FINAL RECOMMENDATION OF THE NORTHEAST DESIGN REVIEW BOARD

Project Number: 3009681

Address: 2746 N.E. 45th St.

Applicant: Mulvanny G2 Architecture for QFC Inc.

SOUTHWEST CORNER OF QFC ADDITION

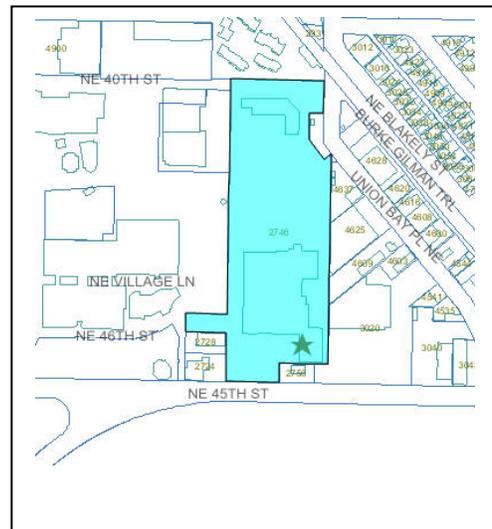
The Board indicated it appreciated the response to their guidance regarding to the front tower element. It indicates transparent windows on either side would be great, but, that well lighted display windows would be adequate, given QFC's programmatic needs. The Board also indicated that the vine covered trellis should be well lighted and the canopies should contain ample down lighting onto the pedestrian path.

Further north, at an element referred to by the Board as the 135 degree corner the Board directed that windows or display windows should be placed one on each side so that an extensive blank wall area is not present in the point of the pedestrian path near the building entry.

The Board indicated that paint colors on the middle tower element along the driveway in from N.E. 45th St. should be balanced. In the materials presented at the meeting an element of dark color was on one side and light on the other leading to an unbalanced appearance.
